TECHNICAL MEMORANDUM

West Harlem Rezoning FEIS

CEQR No. 12DCP070M

FIGURE 1
Comparison of Proposed Zoning Areas to be Modified – FEIS vs. Technical
Memorandum for Potential City Council Modifications

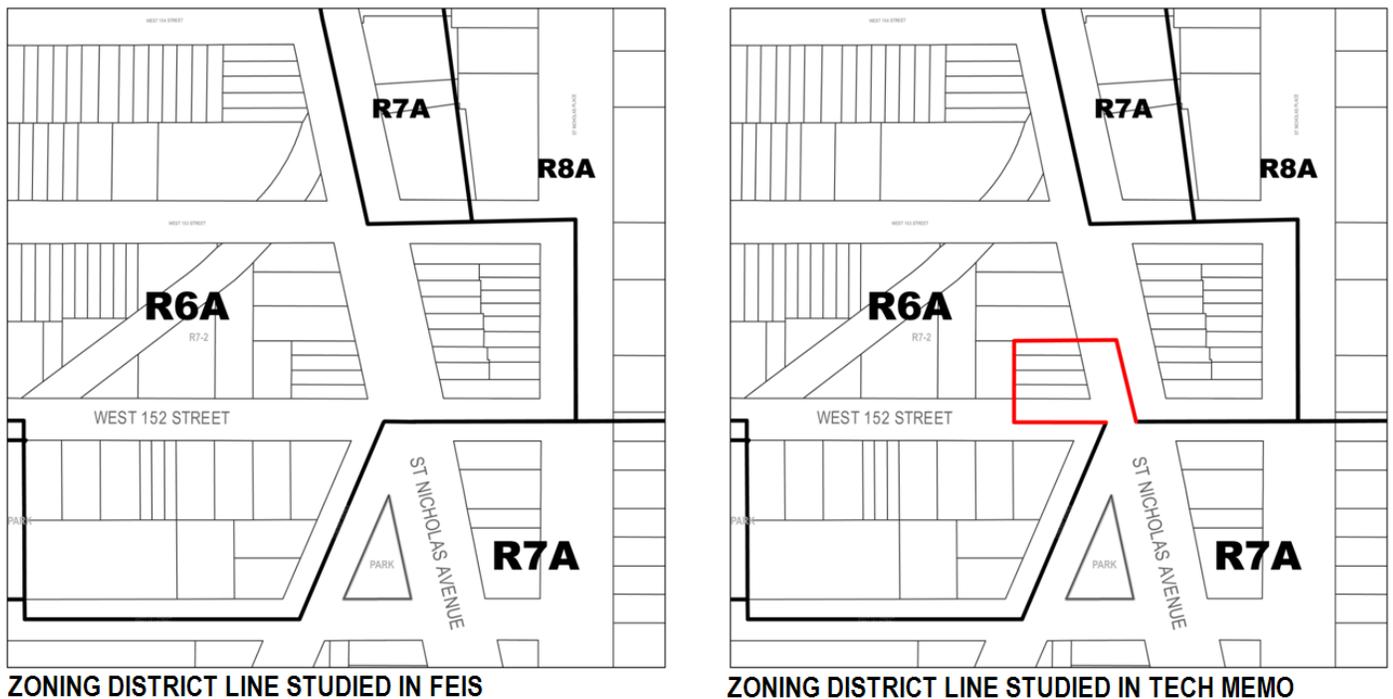
1. Modification to the Proposed Zoning Map Amendment along West 145th Street between Broadway and Amsterdam Avenue and related Modification to Proposed Zoning Text Amendment.

Properties fronting on West 145th street between Broadway and Amsterdam Avenue were proposed to be rezoned R8A with Inclusionary Housing (per the related zoning text amendment) in the FEIS. Pursuant to the Potential City Council Modifications (See “Appendix A”), the R8A with Inclusionary Housing zoning district would be potentially changed to an R7D with Inclusionary Housing zoning district in order to allow residential and community facility development to a lesser extent than the R8A. In conjunction with this modification, the Potential City Council Modifications include a modification to the proposed zoning text amendment to apply the Inclusionary Housing designation along West 145th Street between Broadway and Amsterdam Avenue to an R7D zoning district, instead of to an R8A zoning district.

Five development sites identified in the FEIS are within the area affected by this potential modification: a portion of Projected Development Site 6 (Block 2077, Lot 14), Projected Development Site 8 (Block 2076, Lot 45), Projected Development Site 9 (Block 2076, Lots 40 and 41), Potential Development Site 23 (Block 2077, Lot 6), and Potential Development Site 24 (Block 2077, Lot 24) (See Figure 1).

Since the proposed R7D IH zoning would decrease the height, FAR and development allowable on Projected Development Site 9 and Potential Development Site 23 (See Table 1), this technical memorandum examines whether any new or different significant adverse environmental impacts not already identified in the FEIS will result from the Potential City Council Modifications.
